BLOCK C, WESTERN GATEWAY SUB- PRECINCT

Proponent Response to
Submissions

Prepared for
TOGA
02 July 2021

Figure 1 Visual and View Impacts towards Central Station Clocktower

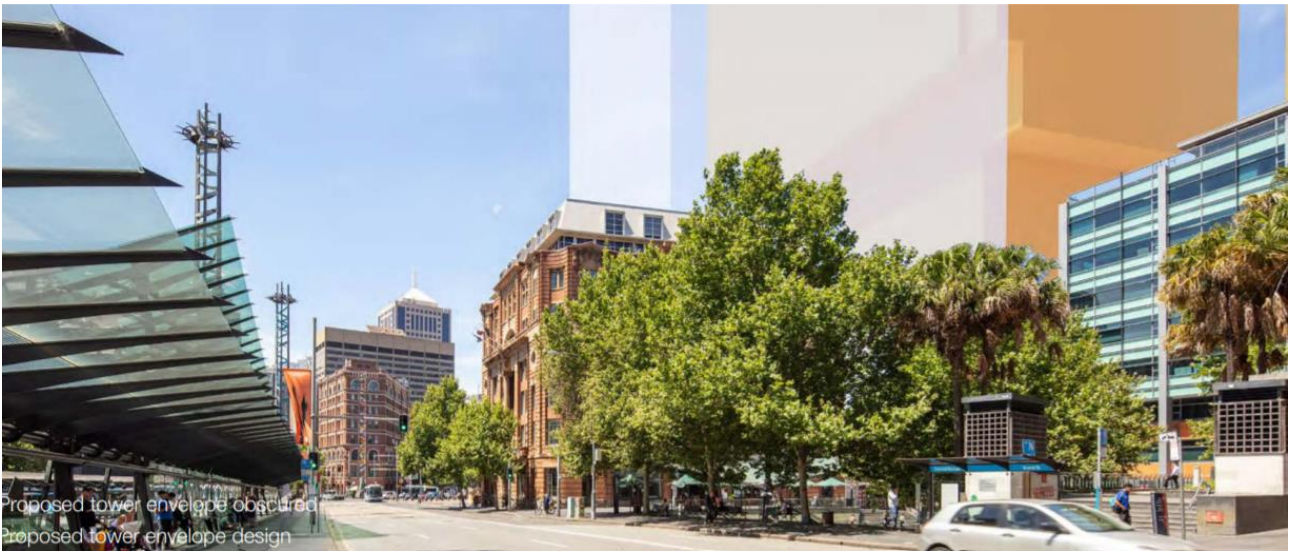
The DRP provided direction to the proponent that, where both could not be achieved, the primacy of the Railway Square / Central Station heritage precinct prevails over theoretical views from Devonshire Street. The extension of the planning envelope into Henry Deane Plaza by 16m will provide a filtered view from the future connection the over station development (OSD) stairs to the Marcus Clark building. The developer is committed to exploring opportunities to emphasise and accentuate this connection where possible through the future Architectural Design Competition for the detailed design of the tower. Specifically, it is noted that the Draft Western Gateway Design Guide is proposed to be amended to require development on Block C to:

(g) Include the use of materials or other measures such as transparent materials and void spaces to ensure a significant portion of the original southern facade can be interpreted from the public domain, and that any enclosure adjacent to the original southern façade is limited as much as possible.

Figure 2 Comparison of setback zones

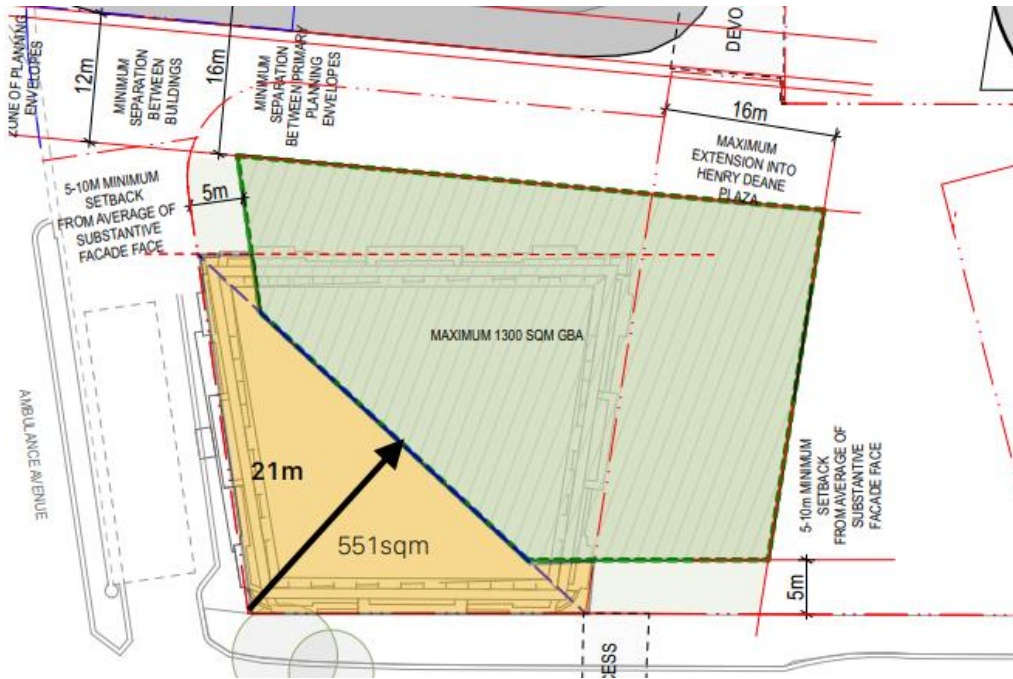
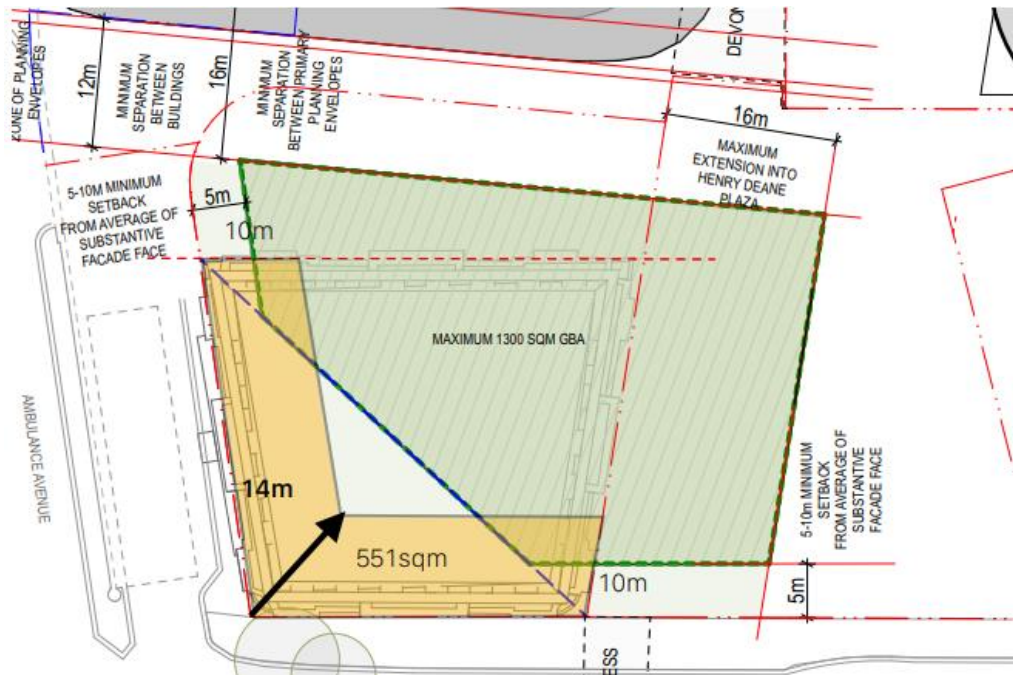
When comparing the proposed setbacks to a 10m setback from the north and west facades without a chamfer (such as if the building were on a corner and subject to the Sydney Development Control Plan 2012 provisions), the setback area is comparable. The proposed setbacks however enable a more usable and logical floor plate that can also provide wind mitigation and maintain view corridors from the site to Central Railway Station.

As such it is concluded that the proposed setbacks from the north and western façades are superior to alternatives.
